EA	04-0120F4
Co-Rte-KP (PM)	SF-080-13.2/13.9 (8.2/8.7)
Structure Rep.	Rick Morrow

File Name:	Sept-29-2008 W2 Cap 004
Date:	09-29-08
By Int:	M Bruce

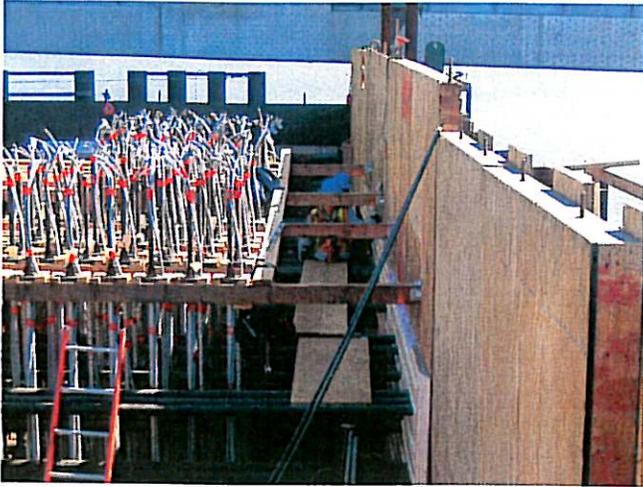
Description: Piledrivers cut 4"x6" support beams to facilitate the short vertical PT bar template installation. A 2"x6" ledger beam was used to try and maintain the alignment of the bars at the top. The batter of the long vertical bars should be checked prior to concrete placement.

File Name:	Sept-29-2008 W2 Cap 008
Date:	09-29-08
By Int:	M Bruce

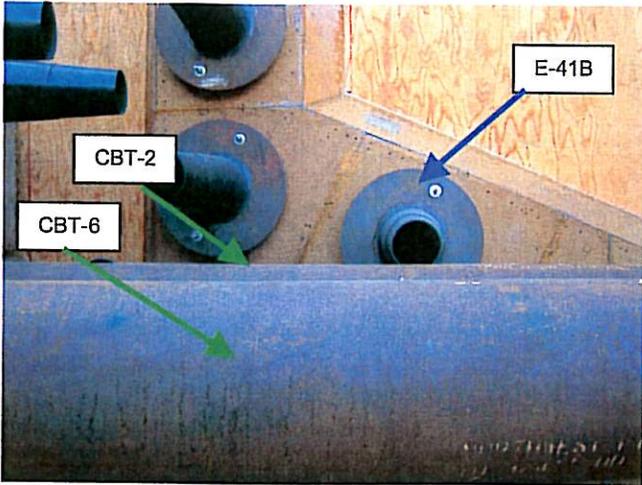
Description: Potential conflict with CBT-2/6 and E-40/41B at W2E looking south.
